MECKLENBURG COUNTY
HEALTH DEPARTMENT

APPLICATION FOR A RESIDENTIAL SITE IMPROVEMENT PERMIT/ CONSTRUCTION AUTHORIZATION
FOR AN ON-SITE WASTEWATER SYSTEM, NEW WELL INSTALLATION, OR REPAIR OF EXISTING WELL

On-site Wastewater Improvement Permit Diagram

IMPROVEMENT PERMIT/CONSTRUCTION AUTHORIZATION for an ON-SITE WASTEWATER TREATMENT & DISPOSAL SYSTEM

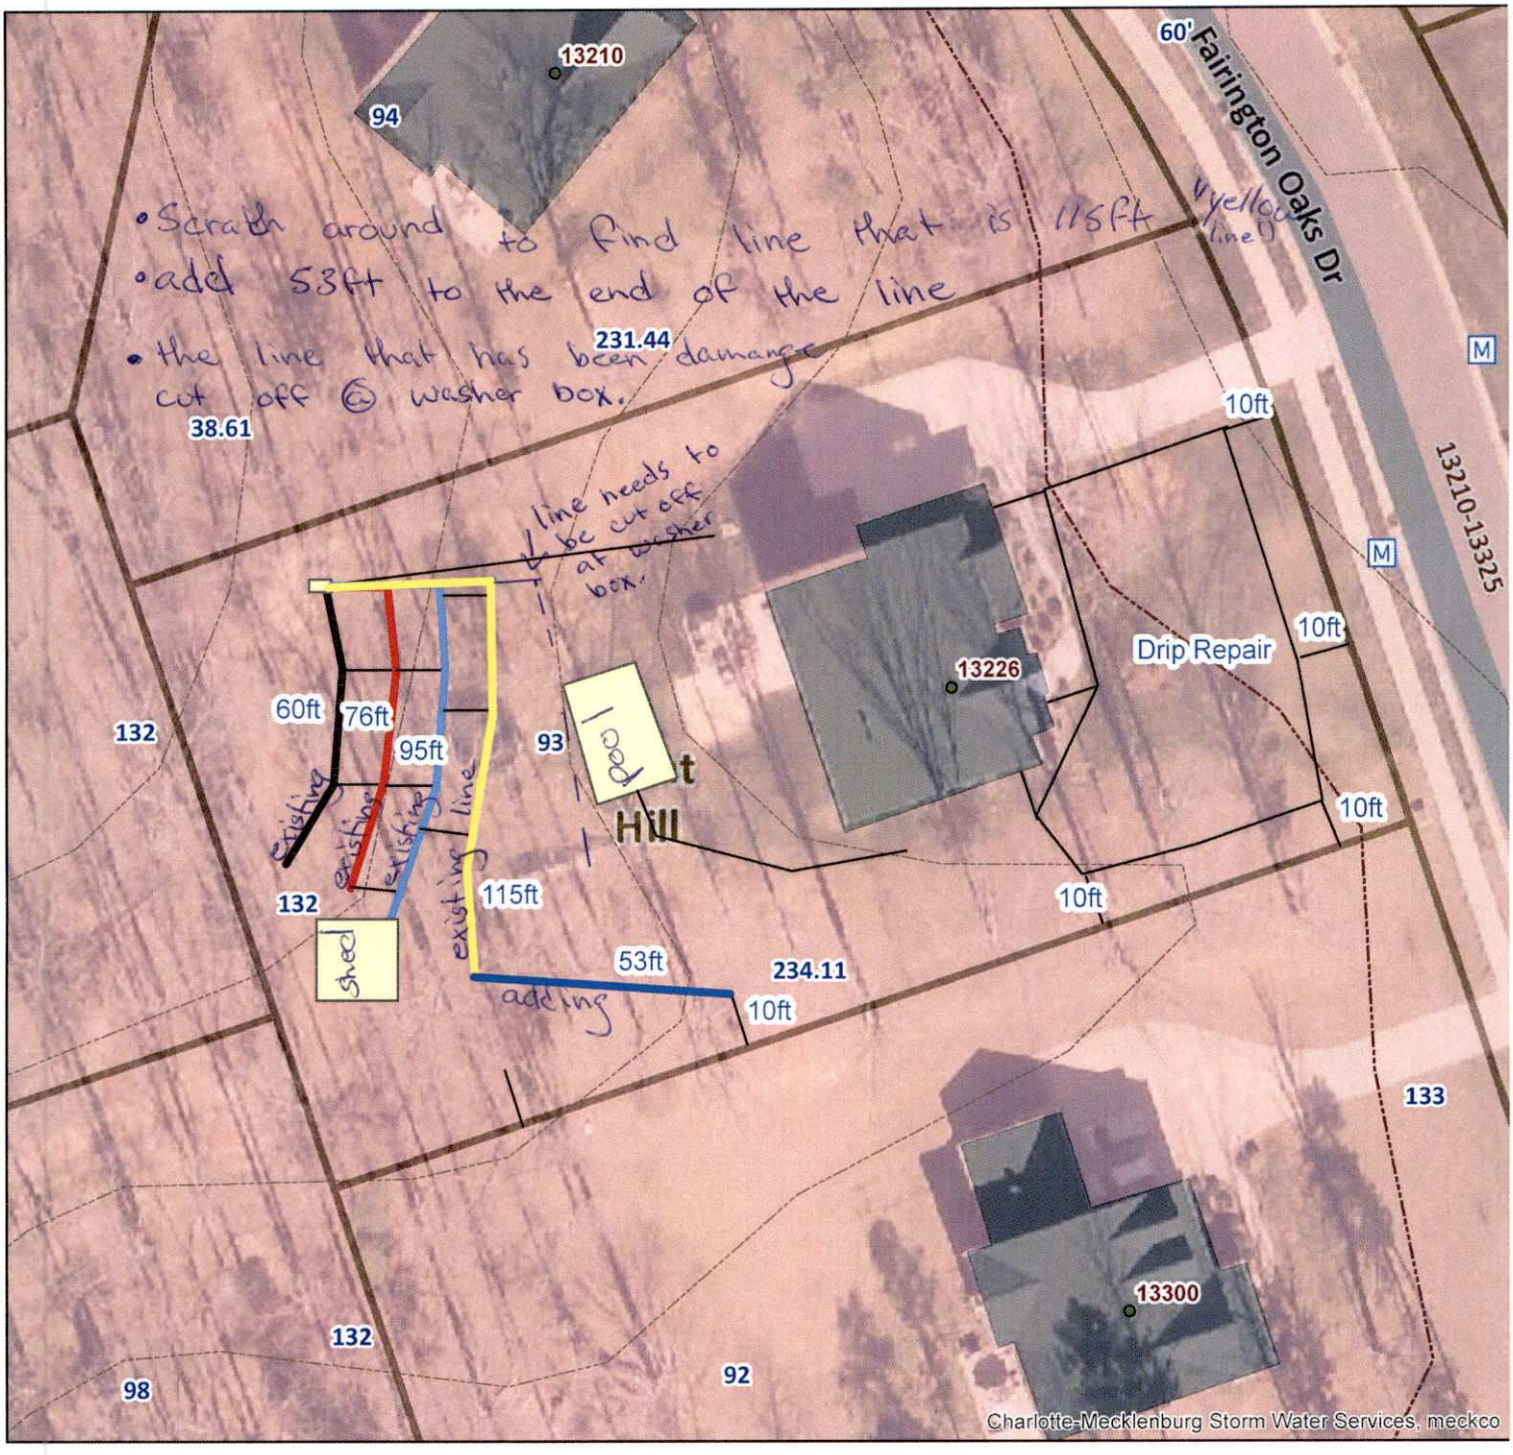
- Adding 1 line 53ft to end of the line
- Scratch around to find the line that is 115ft.
- see attached drawing

7/12/18 - Septic drainfield was driven over to install pool. See pictures.
